ENVIRONMENT & ENERGY COMMISSION

February 23, 2016

EEC Energy Efficiency Recommendations

The Energy and Environment Commissions disagrees with some of the changes to this set of building codes proposed by Building Construction Codes Commission. The changes EEC objects to are struck-through with EEC proposed change(s) next to the struck-through text in bold red

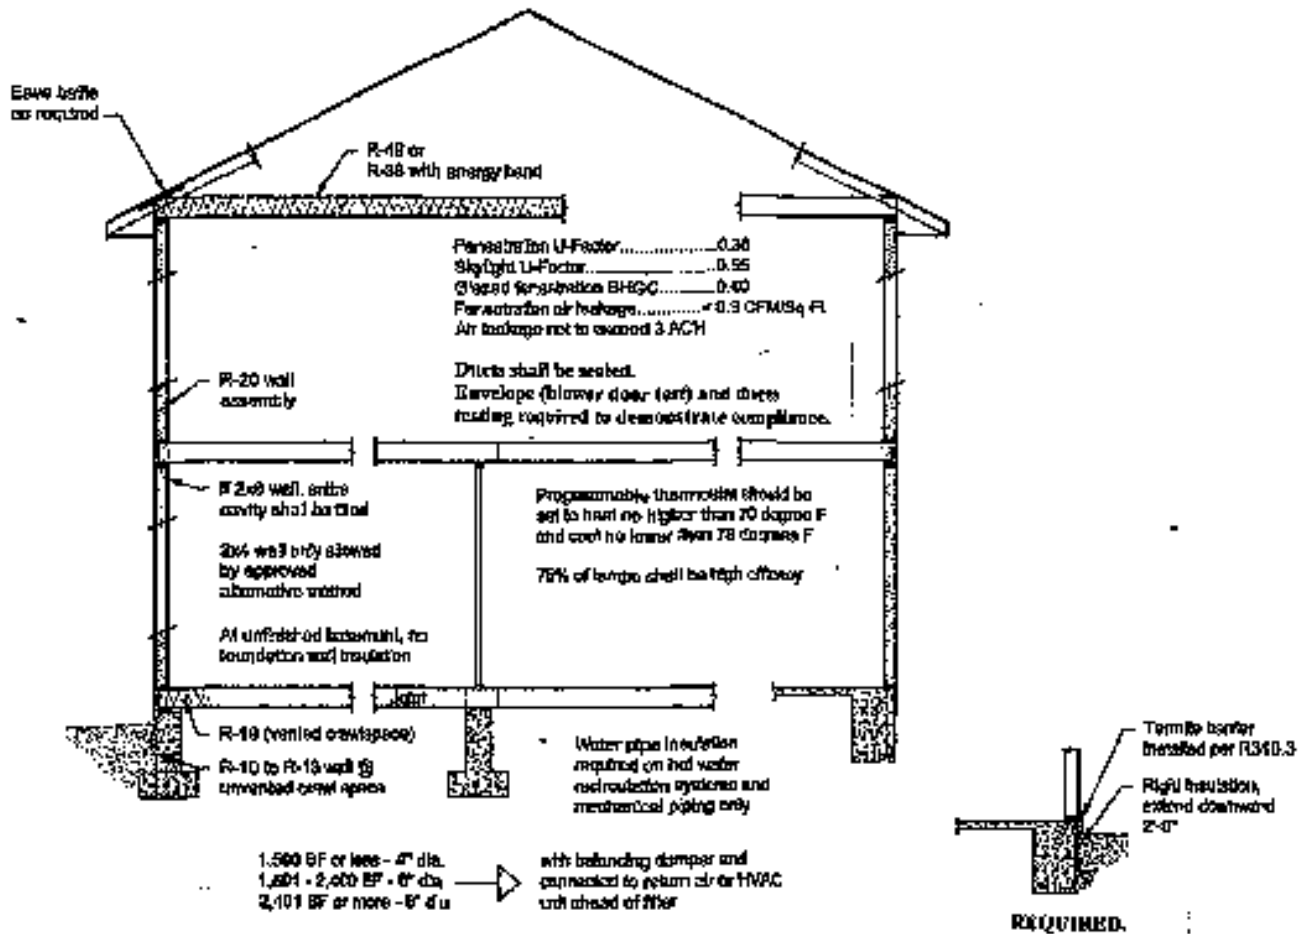
The BCCC has proposed changes that redefine the insulation values for "commercial residential" units that changes energy efficiency for those housing units. (see table below)

Building Area	2015 IECC Table R402.1.2 Residential Code	BCCC Recommended	IRC 2015 IECC Table C402.1.3 Commercial Code
Required Insulation Values			
Ceiling or roof	R49	R38	R38
Exterior wall	R20 or 13+5	R15.5	R13+R3.8 or R20
Floor above crawlspace and ducts in ventilated attic and crawl space	R19	R19	R30
Walls separating garages and other internal but unheated space	R13		R13
Ducts in unheated areas not exposed to outside ventilation	R4	R4	R6 (C403.2.9)
Slab insulation	R10, 2 ft.	Omitted	R10, 2 ft.

EEC recommends that all R1, R2, R3 and R4 classified residential buildings be required to meet IBC 2015 **Residential** Energy Efficiency Code for the following reasons:

FIGURE R301.216
TERMITE INFESTATION PROBABILITY MAP

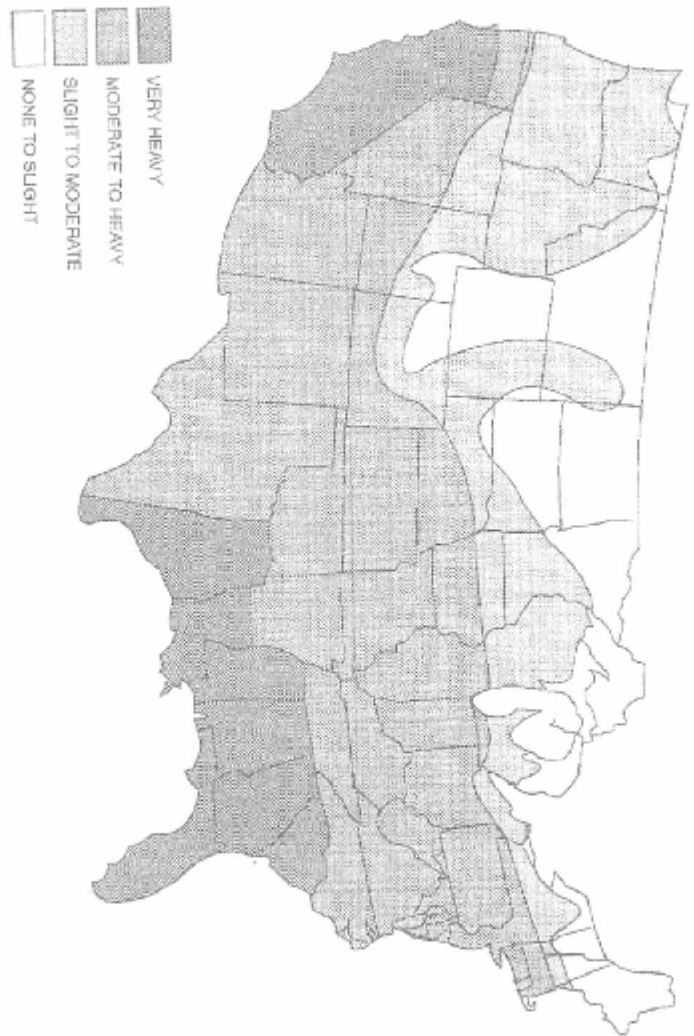
- The 2015 International Residential Code has a map which shows Boone County is in the “Moderate to Heavy” termite region and a large distance from the “Very Heavy” region which is along the Gulf coast, *IRC Figure R301.2(6) TERMITE INFESTATION PROBABILITY MAP*, (attached).

- Changing the infestation probability for our region from “Moderate to Heavy” to “Very Heavy” gives credibility to the idea that foundations should be uninsulated to allow for easy viewing by termite inspectors.

The 2012 International Building Code, which was previously adopted by the City, contains section R318.3 which describes a solution to the problem of termite infestation being hidden by insulation. This section requires foundation insulation with termite shields. The EEC recommends that no changes be made to existing codes that remove the requirement for slab floor foundation insulation with termite shields.
